Dear Valued Customer,

This letter is being sent to all customers that have purchased our Heritage motorcycle trailer since August of 2017. It has come to our attention that the welds of the axles may be inadequate. Before further use you must have additional weld added to the points where the axle collet meet the upright.

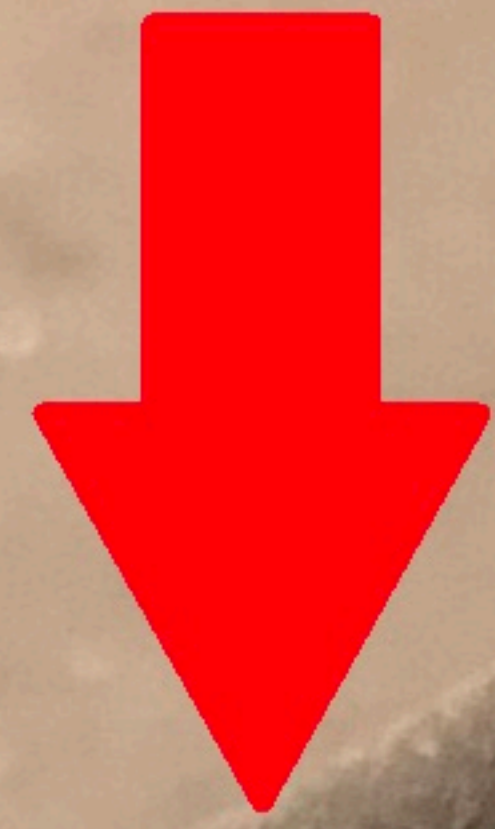
Attached you will find a diagram showing where the additional weld must be added. We are authorizing up to 100.00 in repair costs. Please submit copies of the receipt for repair and we will make reimbursement. Along with the receipt please include the name of the payee and the address to which the check should be mailed.

**WELD SAME AREA
ON OPPOSITE SIDE**

WELD ACROSS
